The Secretary
NSW Department of Planning, Industry and Environment

12 May 2021

I refer to the Department's below email of 10 May 2021 regarding the notice of exhibition of the Environmental Impact Statement (EIS) for State Significant Development SSD-9579147 Pendle Hill High School Redevelopment at 66 Binalong Road, Toongabbie (Lot 101 DP 1141329). Submissions need to be made to the Department by 8 June 2021.

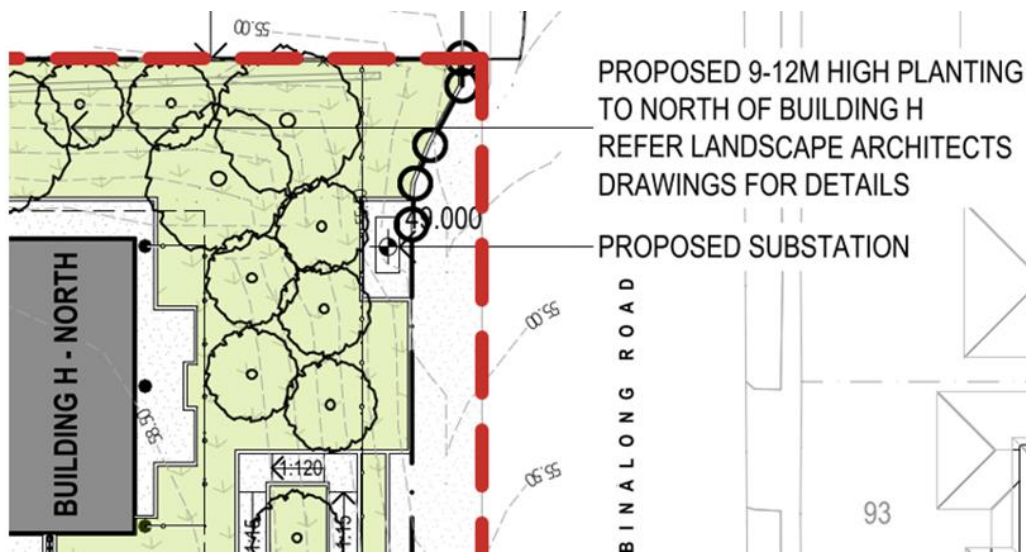
The proposed new padmount substation to be installed along Binalong Road is shown in the following extract of the Proposed Site Plan.

From Endeavour Energy's perspective the fact that provision is being made for a padmount substation is a positive. Endeavour Energy's general requirements is for a padmount substation to be at ground level and have direct access from a public street (unless provided with appropriate easements for the associated underground cables and right of access).

A4.3 - Padmount easements and clearances

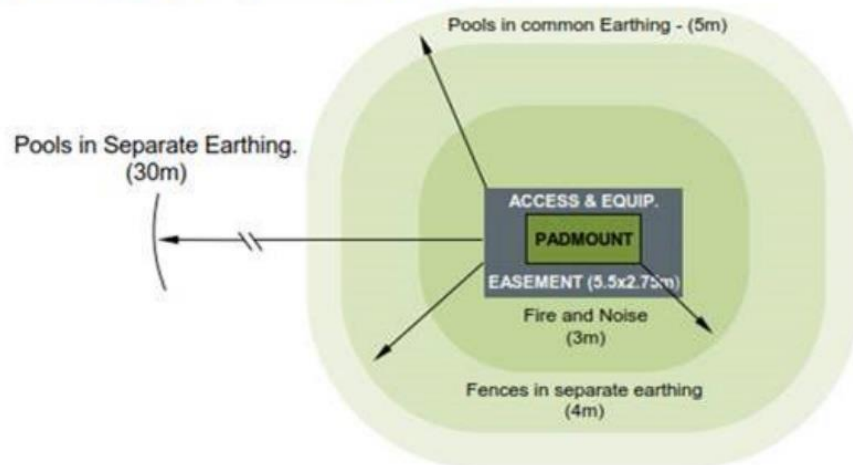
As shown in the following extract of Endeavour Energy's Mains Design Instruction MDI 0044 'Easements and Property Tenure Rights', Figure A4.3 'Padmount easements and clearances', padmount substations require:

- Easement with a minimum size of 2.75 x 5.5 metres (single transformer).
- Restriction for fire rating which usually extends 3 metres horizontally from the base of the substation footing / plinth and 6 metres vertically from the same point.
- Restriction for swimming pools which extends 5 metres from the easement (which may not be required for non-residential use).

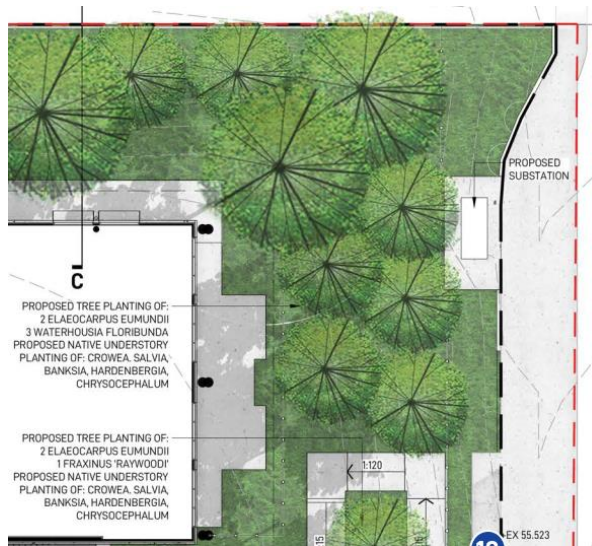
As shown in the following extract of the Landscape Master Plan the proposed extensive tree planting between the padmount substation and Building H – North will need to reconsider if the proposed plantings achieve the foregoing requirements. In addition, as per Endeavour Energy's previous submission, appropriate planting needs to occur in proximity of the overhead power lines to the Binalong road road frontage needs to be considered.

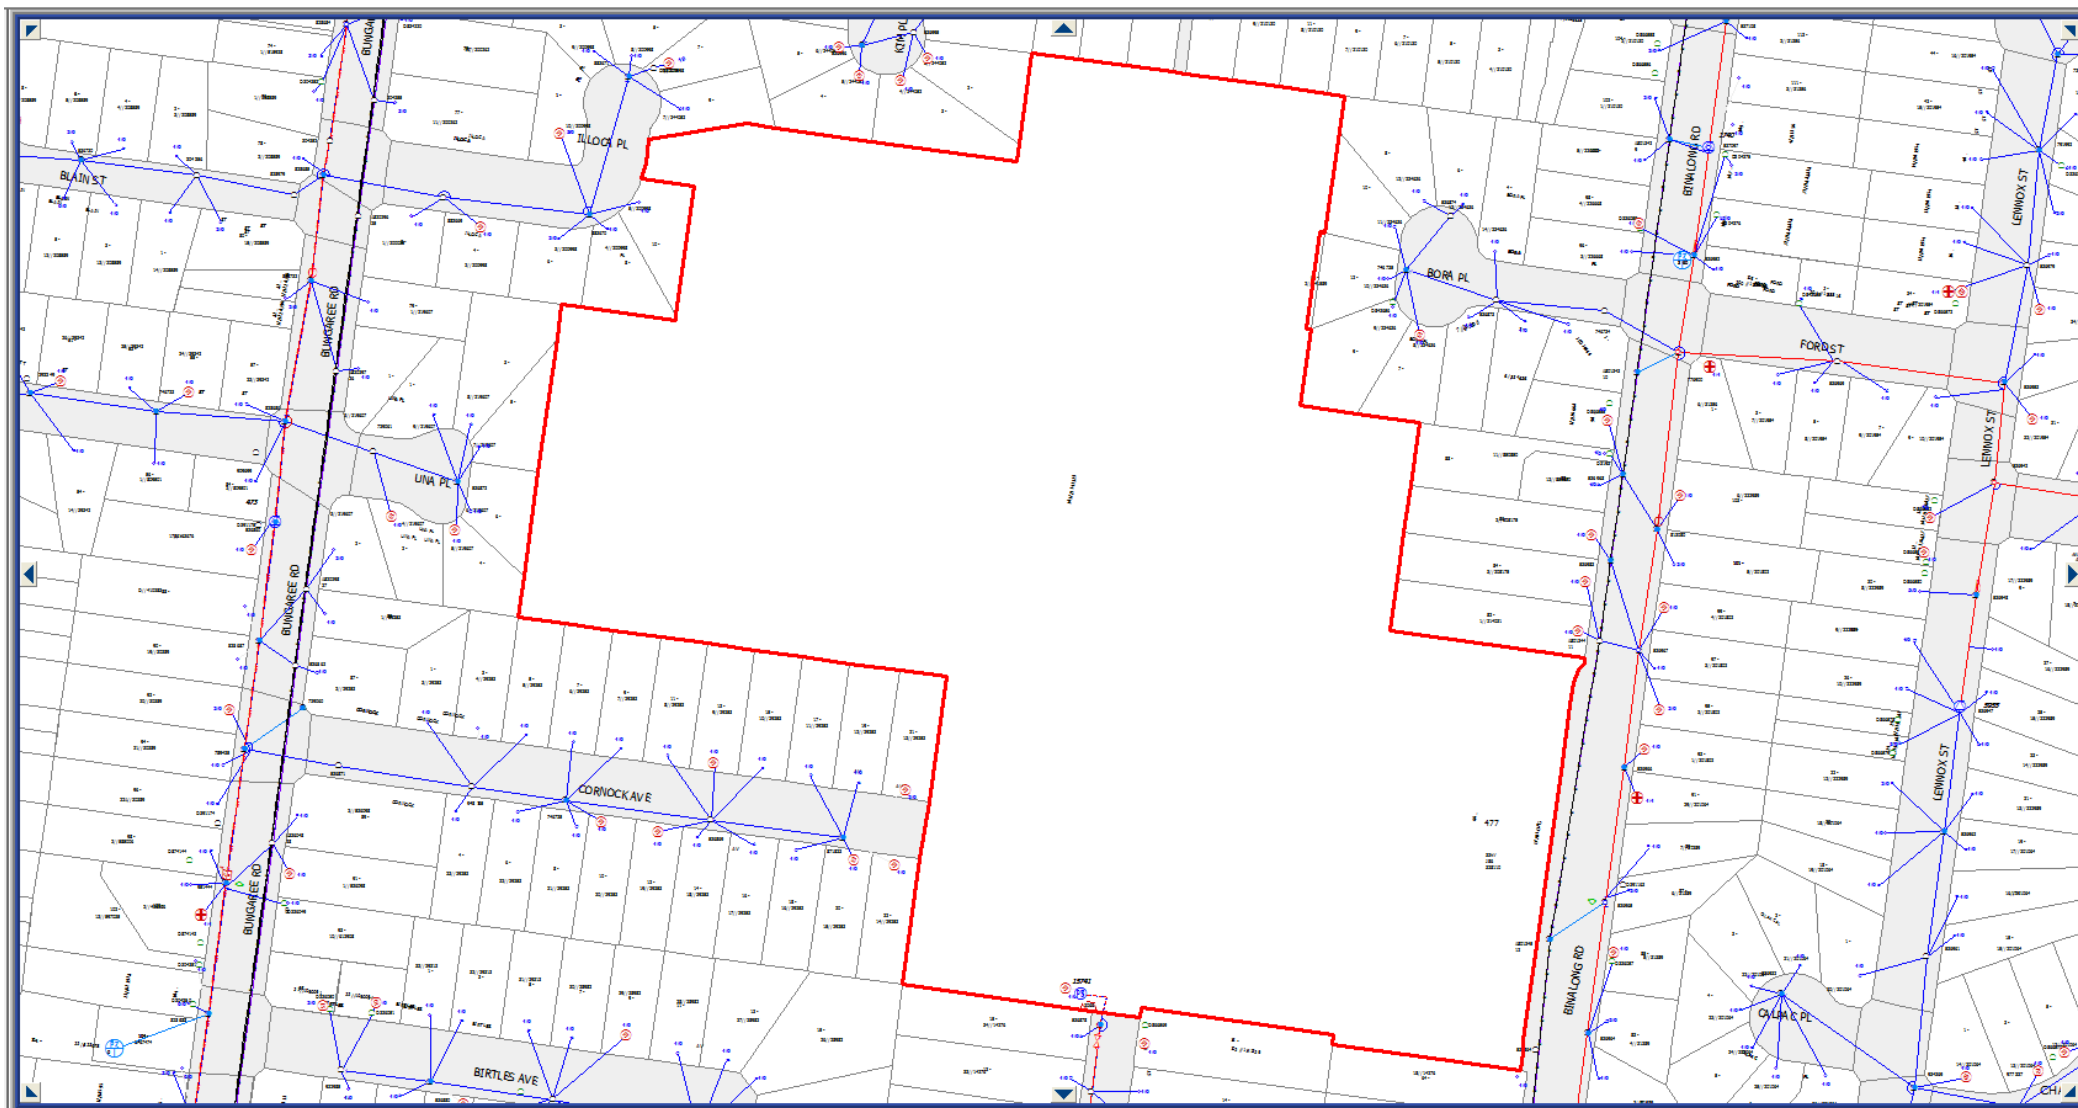
Supply for the new padmount substation to the Binalong road frontage will need to be provided by the 11,000 volt / 11 kilovolt (kV) on the opposite side of the road. As well as the provision of the new padmount substation, other factors such as the size and rating / load on the conductors and voltage drop (which can affect the quality of supply particularly with long conductor runs) etc. need to be assessed.
